## RECOMMENDED SERVICE BULLETIN

Model DA 40

## RECOMMENDED SERVICE BULLETIN NO. RSB 40-094 REV. 1 SUPERSEDES RSB 40-094 REV. 0

Installation of insulation around the fuel supply line from the engine driven pump to the fuel servo.

Figure 1. Installation drawing.

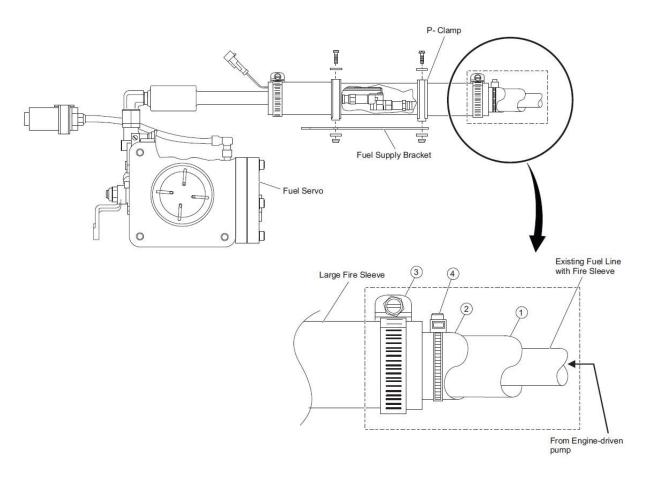
- 7. Install the new firesleeve (item 1):
  - A. Coat both ends of the firesleeve with a first coat of firesleeve end dip (item 5). Ensure 50 mm (2 in) of the inner surface of both ends of the firesleeve are coated.

- B. Wipe excess end dip from the outside of the firesleeve. Allow the first coat to dry.
  - C. Coat both ends of the firesleeve with a second coat of firesleeve end dip. Ensure 50 mm (2 in) of the inner surface of both ends of the firesleeve are coated.

- D. Wipe the excess end dip from the outside of the firesleeve. Allow the second coat to dry.
  - E. Install the new firesleeve over the fuel supply line, and under the existing large firesleeve. Refer to Figure 1.

Figure 2. Installation, rear view.

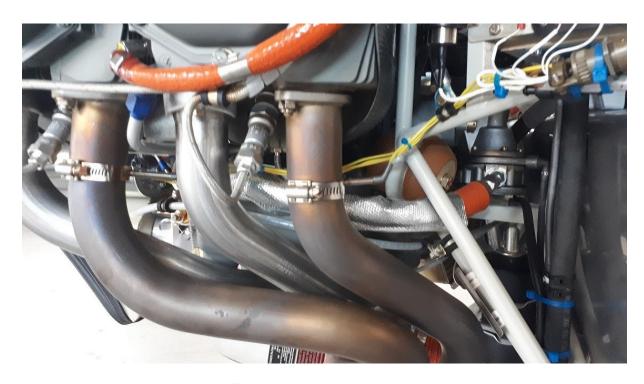
NOTE: Refer to Figure 1 for the installation drawing. Refer to Figures 2 and 3 for photos of the installation.

- 8. Install a new hose clamp (item 3). Ensure the new firesleeve is secure under the clamp.
- 9. Install the reflective sleeve (item 2). The reflective sleeve should start against the aft end of the existing large firesleeve. Do not insert the reflective sleeve under the large firesleeve.

Figure 3. Installation, front view. Note that item 4 has not yet been installed.

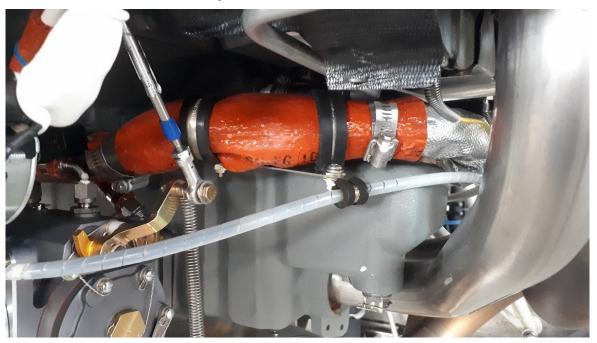
- 10. Secure the reflective sleeve with a fire resistant cable tie (item 4).
- 11. Connect the fuel supply line to the engine driven pump.
- 12. Connect the airplane battery. Refer to AMM Section 24-31.
